REGIS T. REPKO  
Vice President  
McGuire Nuclear Station

Subject: Duke Energy Carolinas, LLC (Duke Energy)  
McGuire Nuclear Station, Units 1 and 2  
Docket Numbers 50-369 and 50-370  
Technical Specifications (TS) Sections:  
3.3.2, Engineered Safety Feature Actuation System (ESFAS) Instrumentation  
3.5.4, Refueling Water Storage Tank (RWST)  
3.6.6, Containment Spray System (CSS)

License Amendment Request for Emergency Core Cooling System (ECCS)  
Water Management Initiative

Figure 3.2.1-1

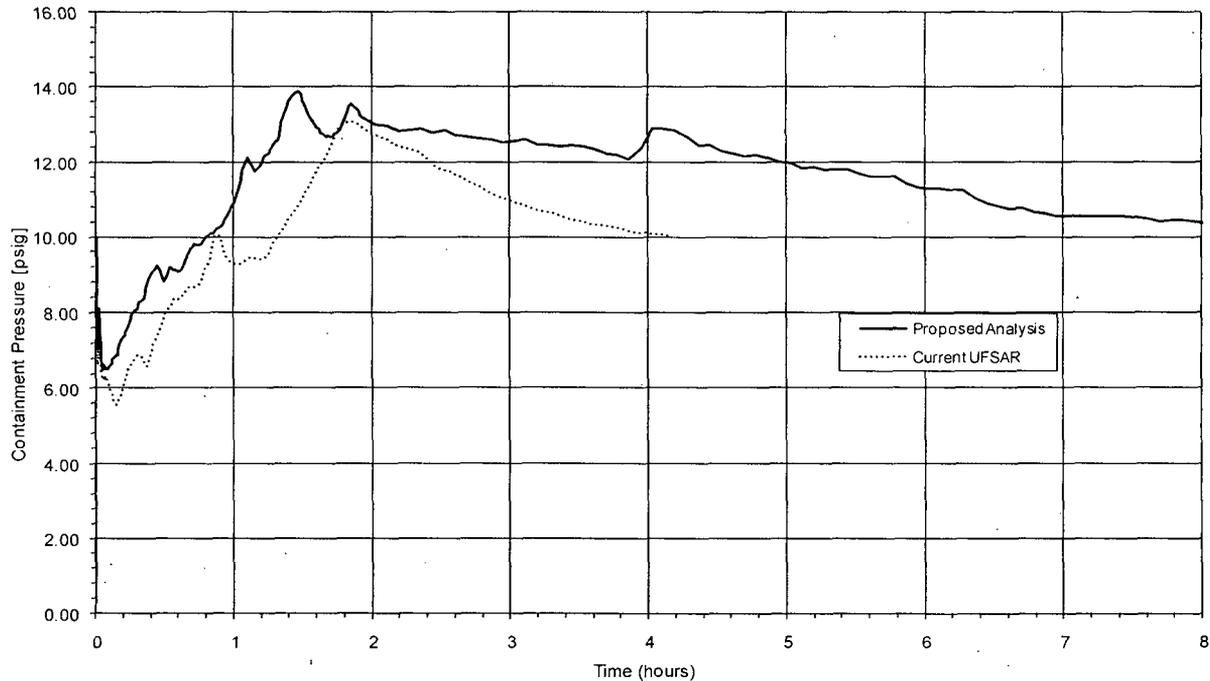
Two phenomena previously not included in McGuire peak containment pressure response analyses were observed. The first phenomenon, intact loop seal refilling, directly affects the containment pressure response. The current containment analysis diverts flow from the RHR pump from the cold legs and core cooling, to be used as auxiliary containment spray. The reanalysis keeps this flow aligned to the cold legs. For a cold leg break, the core steaming rate decreases with decay heat. The majority of the steam generated in the core passes through the broken loop and is released to containment. A fraction of this steam is drawn through the intact loops by the condensation of steam by cooler ECCS injection. Eventually the steam velocity in the intact legs decreases to the point where liquid spills over the reactor coolant pump weirs and refills the intact loop seals. At this point in time, all of the steam generated in the core exits the broken loop into containment to be condensed. In Figure 3.2.1-1 shown below, this occurs just before four (4) hours.

The second phenomenon observed is a significant increase in the amount of reverse break flow. This is steam predicted to be drawn from containment into the RCS by steam condensed on subcooled ECCS injection. The Duke Energy containment response methodology is an iterative method that uses GOTHIC for the containment response calculation and RELAP5 for the mass and energy release calculation. Steam predicted to be drawn from containment into the RCS in the RELAP5 calculation is not removed from the GOTHIC calculation. This steam flow is non-conserved mass and energy. In the present containment response calculation, the predicted reverse break flow is a penalty incorporated in the results. For the reanalysis, the magnitude of this penalty is such that it was desirable to mitigate this flow. The ECCS steam condensation rate in the cold legs is mitigated by the inclusion of nitrogen in the RELAP5 containment boundary condition. This change reduced the magnitude of the reverse break flow penalty.

Figure 3.2.1-2

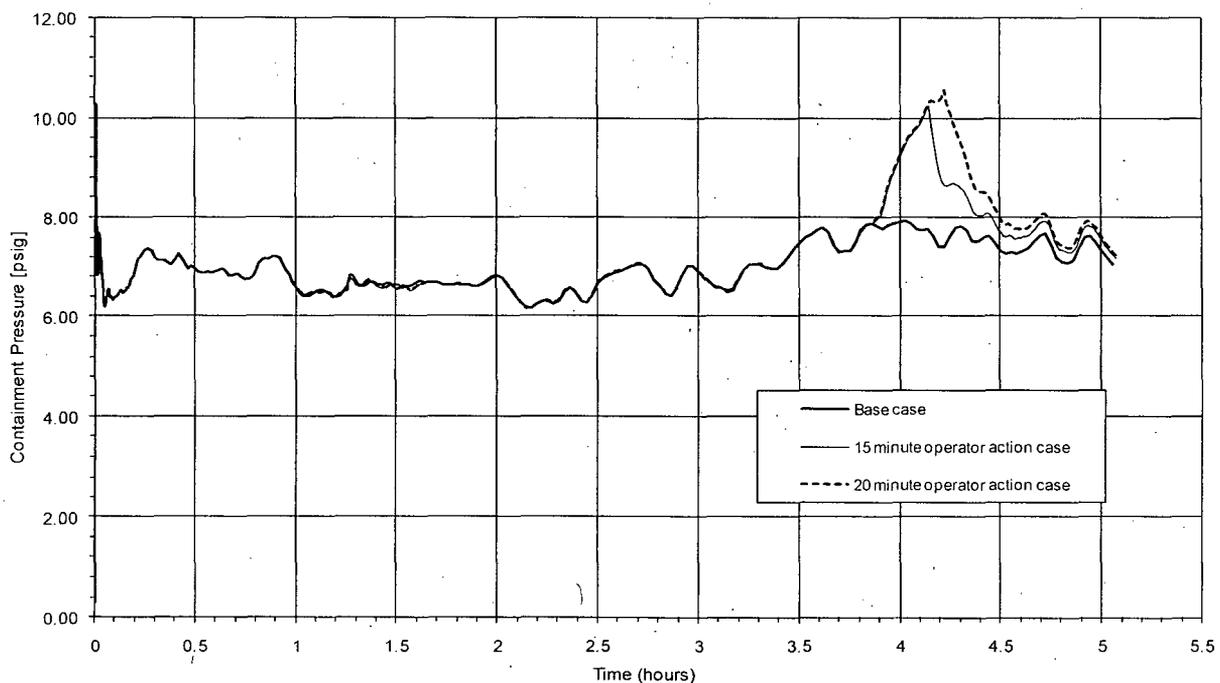
A sensitivity study has been performed to evaluate the containment pressure response to a CS Pump failure. The pump is assumed to fail at the time of peak pressure for the event. The results of this sensitivity study, shown on Figure 3.2.1-2, indicate that 20 minutes are available for operator action to initiate CS spray flow from the idle spray pump. If CS flow is initiated within 20 minutes, the peak containment pressure will remain below the containment design pressure. Operator action is reasonably achievable within the 20 minute timeframe.

Figure 3.2.7-1  
 McGuire LBLOCA Sump pH Response for Proposed Amendment

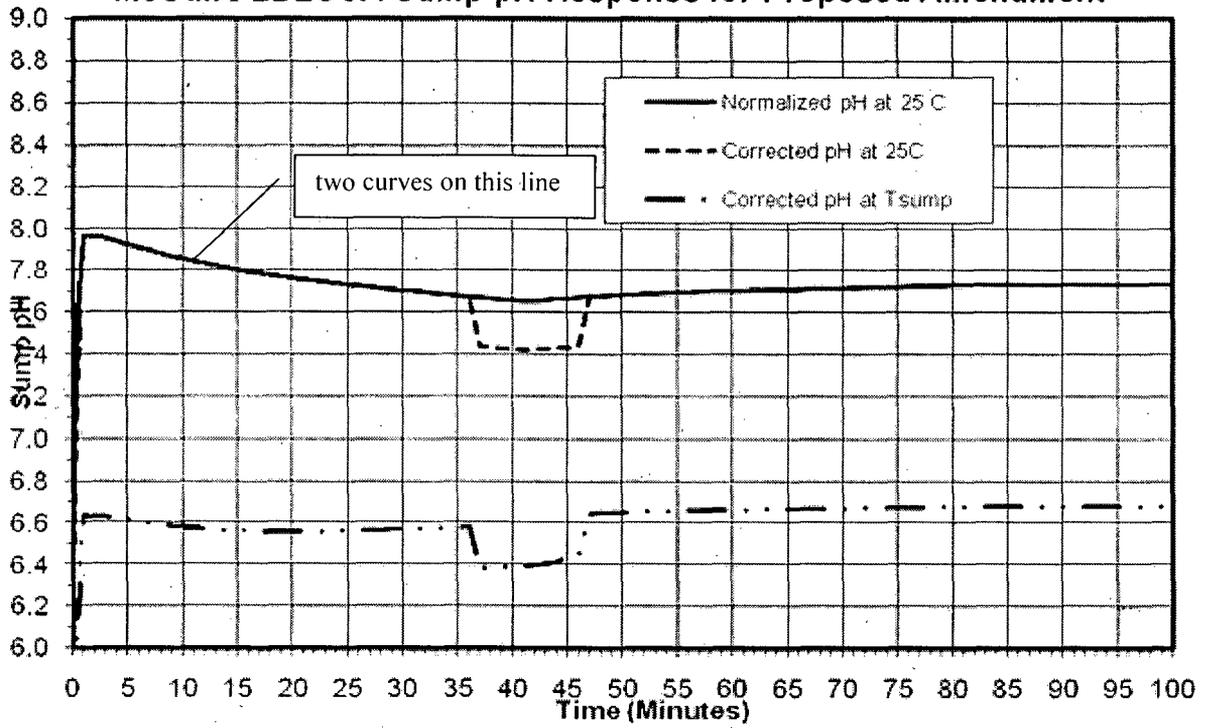
The CLB post-LOCA sump pH profile was provided in Reference 6. The proposed amendment post-LOCA sump pH profile is shown in Figure 3.2.7-1. This figure continues to show three curves: the corrected sump pH at the elevated sump temperature, the normalized sump pH at the standard temperature (25 °C), and the corrected sump pH at 25 °C. The "corrected pH at  $T_{\text{sump}}$ " curve continues to be used as the input to the spray lambda calculations. The description of this application and the justification for it supplied in Reference 7 continue to be valid for models associated with the proposed amendment.

Figure 3.2.7-2  
 McGuire LBLOCA Sump Concentrations

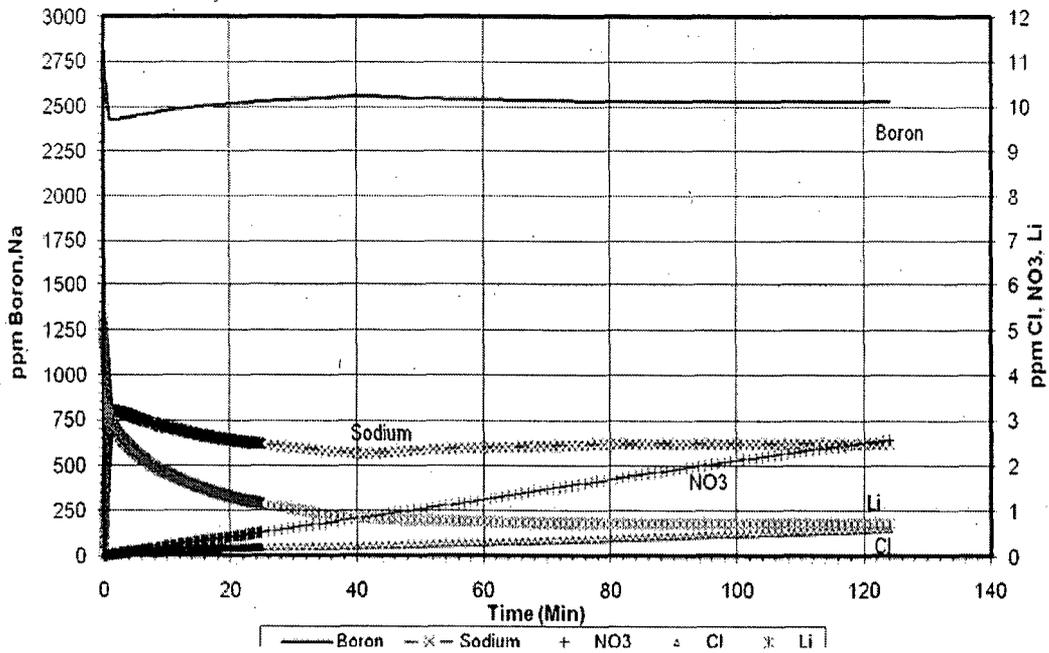
The ice condenser total ice melt mass is the same under the proposed amendment, but the time dependant profile of the ice melt is different. These profiles are compared in Table 3.2.7-2. There is no change to the cable insulation mass modeled or the types of cable insulation assumed. The conclusions in Reference 7 regarding the sensitivities of the sump pH model to these variables and regarding the variation in sump pH over the full 30 days (drawn from hand calculations) are not impacted by the proposed amendment. The concentration of the acids in the sump, under the amendment, is shown in Figure 3.2.7-2.
